# INITIAL FIRE SAFETY INSPECTION REPORT

**Tropical Knitex Ltd (Extension 2)**

**RSC ID: 26521**

**Date: 19-November-2025**

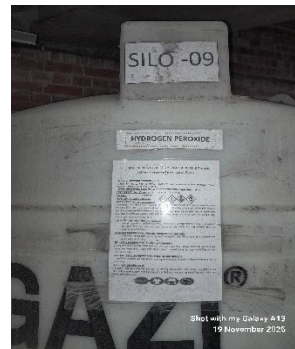
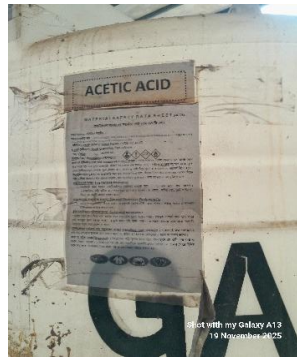
F-3	Means of Egress	<p>Posted Fire evacuation maps are not updated as per site conditions.</p> <p><b>Location(s): Building-22.</b></p>	<p>Update the fire evacuation map and shall be posted at the entrance to each exit stair in accordance with RSC Technical Guidelines (Standard)<sup>1</sup> V1.0 Section 13.3.</p>	<p>Within 1 Month</p>
F-4	Means of Egress	<p>Aisles were found missing in several locations.</p> <p><b>Location(s): Building-22.</b></p>	<p>Provide minimum aisle widths of 36-in. Aisles mark shall be clearly visible.</p>	<p>Within 1 Month</p>

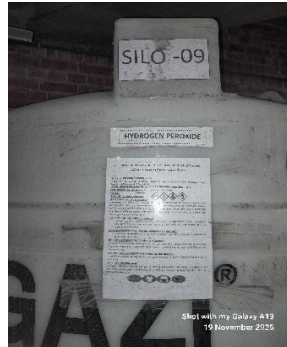
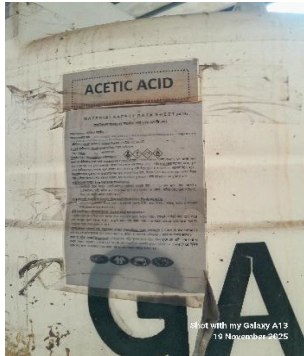
<p><b>F-16</b></p>	<p>Fire rated construction</p>	<p>Elevator shafts open directly into the exit enclosure, which doesn't comply with RSC Technical Guidelines (Standard), section 6.14.3.</p> <p><b>Location(s): Both exits, Building-22</b></p>	<p>Provide a minimum 2-hr fire rated elevator shaft to separate it from stair enclosure. No discharge is accepted through elevator shaft. Seal all openings to maintain fire separations.</p>	<p>Within 3 Months</p>
<div style="display: flex; justify-content: space-around;">   </div>
